# Product Safety Recall

## YAMAHA TMAX Motorcycle Main Stand Breakage

MODEL	MODEL YEAR	FRAME NUMBER		
		PREFIX No.	FROM	TO
TMAX	2017-2019	SJ144	000001	000084

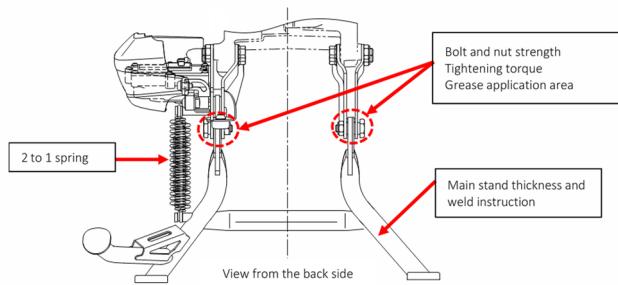
The strength of the XP530A main stand may be compromised due to substandard welding at the cross tube.

Repeated operations of the main stand may cause cracking at the weld areas and possible breakage. If the stand was to break and the bike was to fall over, it could cause serious injury to the rider or bystanders.

To correct this defect, Yamaha is initiating a Factory Modification Campaign, whereby affected XP530A models must have the main stand replaced with one that has been strengthened by increasing the tube thickness and modifying the welding process.
